DATE: August 5, 2015  
AGENDA ITEM # 3

**TO:** Design Review Commission  
**FROM:** Zachary Dahl, Senior Planner  
**SUBJECT:** 15-SC-27 – 540 Deodara Drive

Approve design review application 15-SC-27 subject to the findings and conditions

Appendix 1: Inventory Map and Spreadsheet

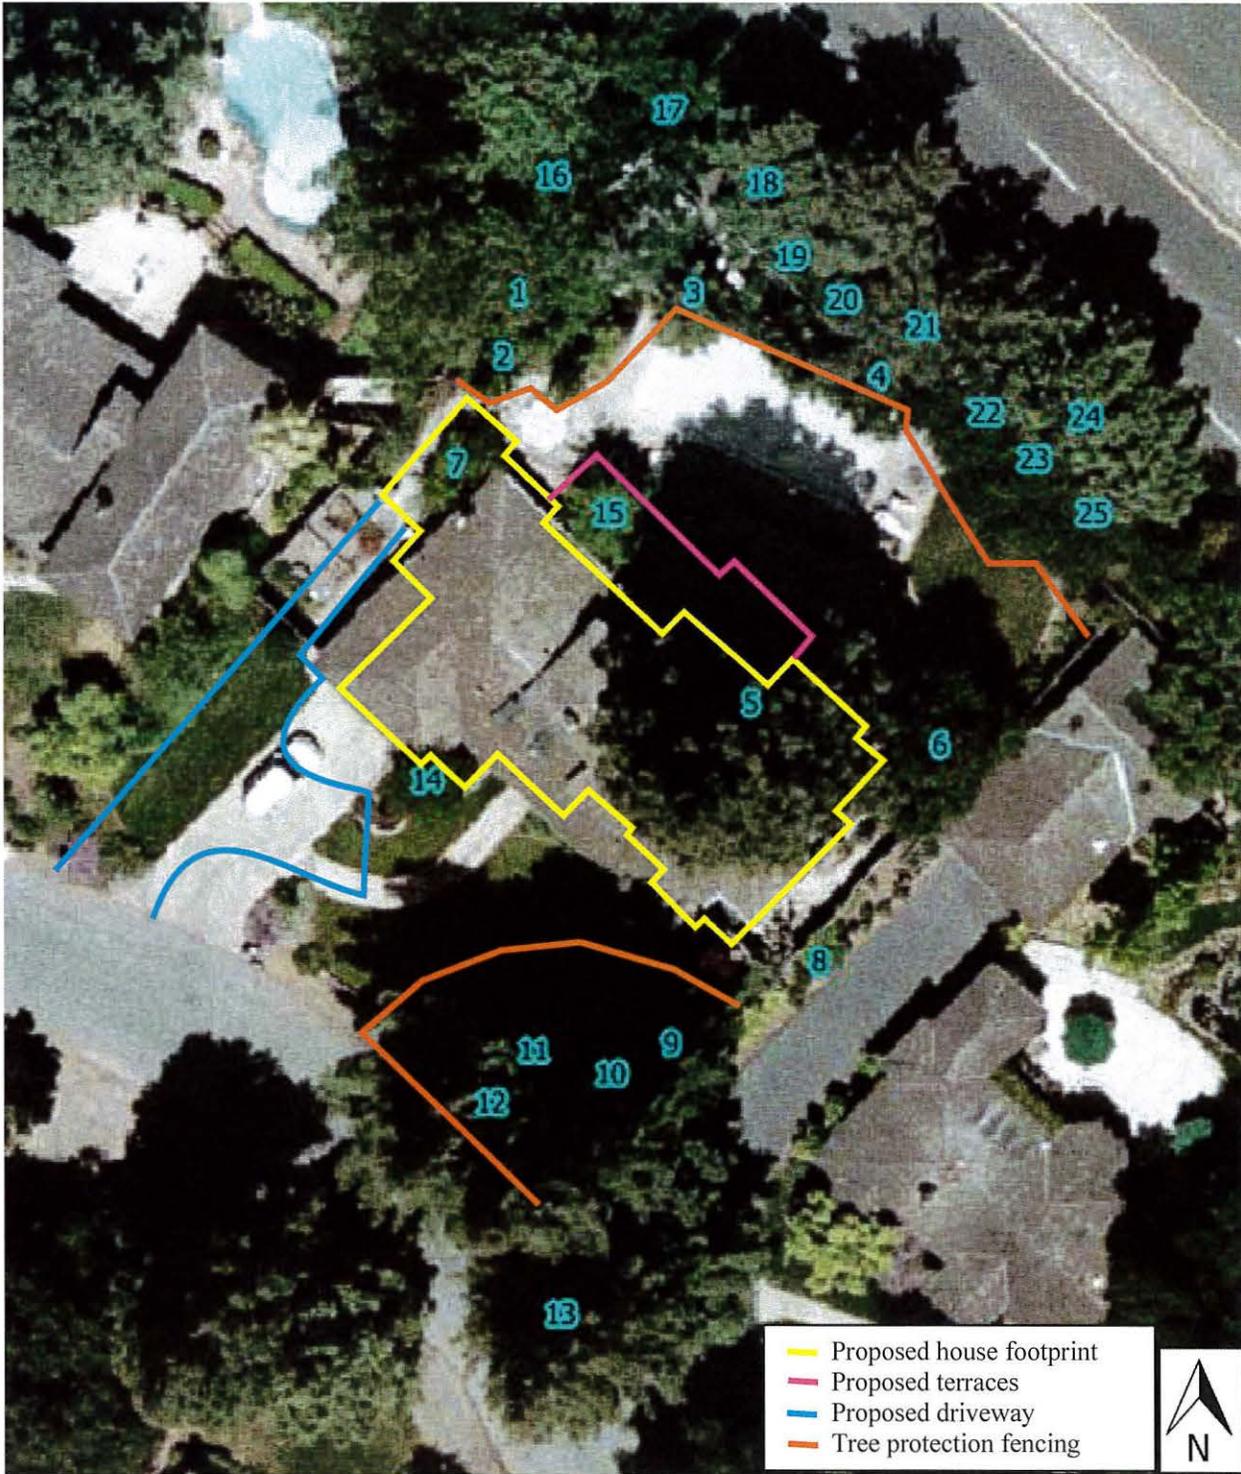
5. Tree protection fencing must be installed before any equipment comes onsite, per the map below. Tree protection fencing is to remain in place throughout construction.

6. Tree protection shall be installed at or beyond the driplines of all trees except where existing pavement is to be retained, as on Deodara Drive.
7. Tree protection fencing shall consist of six-foot high chain link fencing. Tree protection fencing shall be posted with signs saying "TREE PROTECTION FENCE – DO NOT MOVE OR REMOVE WITHOUT APPROVAL FROM ARBORIST."
